CITY OF EL PASO DE ROBLES
"The Pass of the Oaks"

BID ADDENDUM NO. 1

Dry Creek Road Repairs

DPW PROJECT NO. 17-19C

City of Paso Robles
 1" = 500'
 Dry Creek Road Rehab Project
 Control Point Map

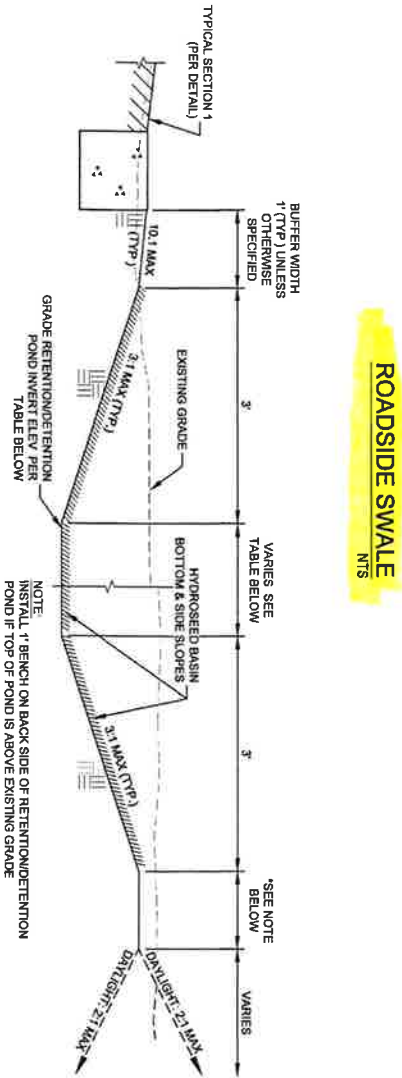
-
1. See attached additional information with regards to establishing construction survey controls (horizontal and vertical). Also, City will provide 3D CAD files to successful contractor.
 2. Per TS-9 Roadway Excavation, there are no compaction requirements below the 18-inch pulverized materials.
 3. Question: TS-10.06 General Application – Paragraph 2 and Plan Sheet 14 Typical Section 1 Paragraph 2 states the maximum treatment is 12-inch. Plan sheet 14 Typical Section 1 indicates 13-inch. Which one applies?

Attachment A, "Survey Control Points Table" & Attachment B, "Monument Table" convey the control points and monuments provided to PEI in the original topographic survey file. Attachment C, "Centerline Horizontal & Vertical Information" provides information about the beginning and end of the centerline stationing included in the Plans.

DETAILS

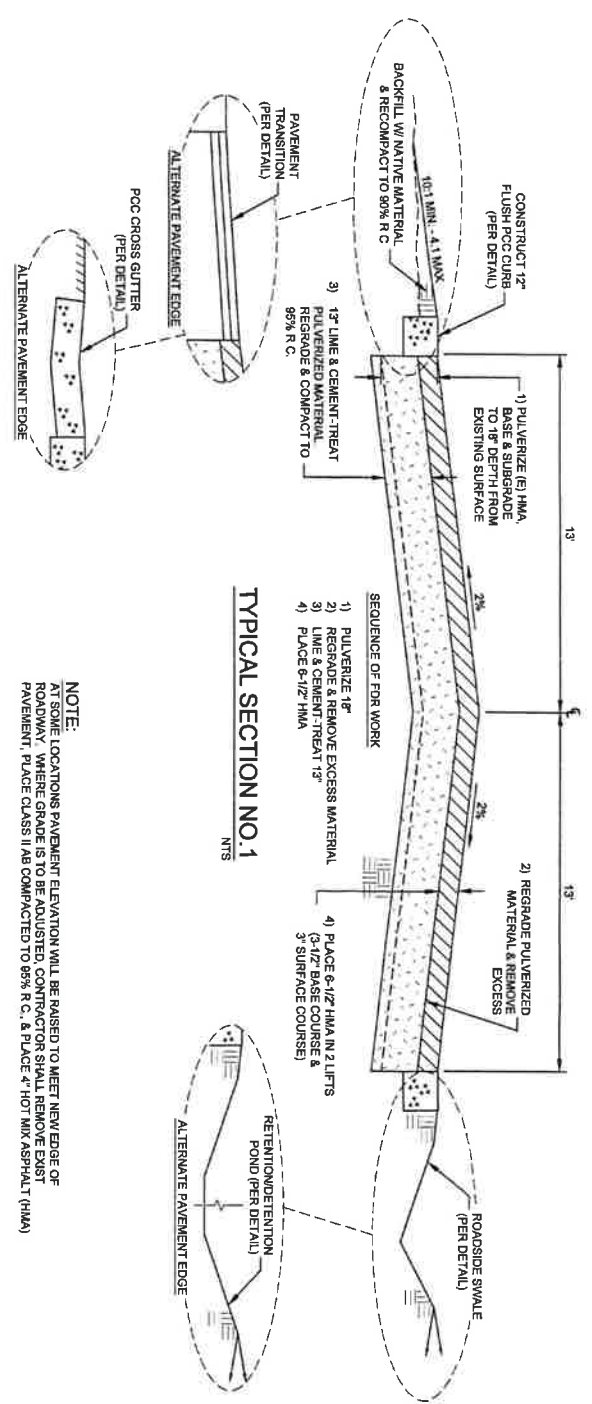
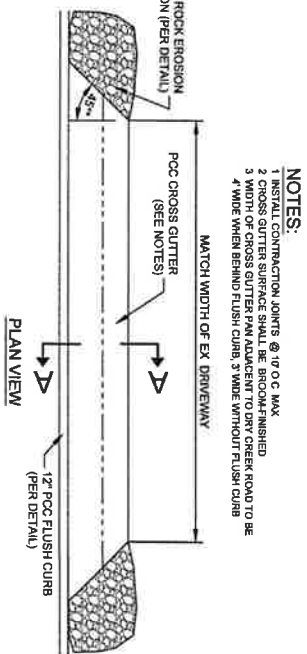
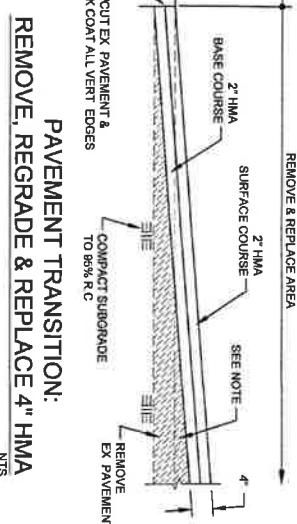
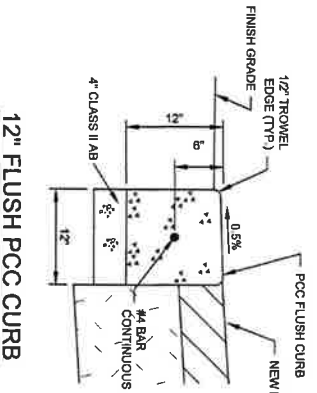
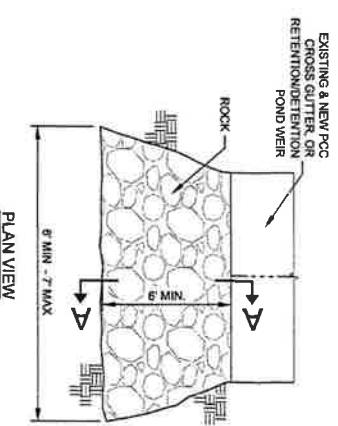
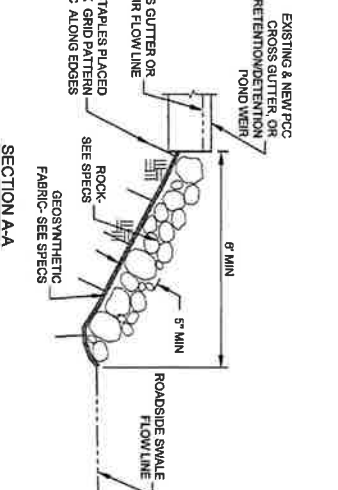
13. See revised Roadside Swale Detail on sheet 14.
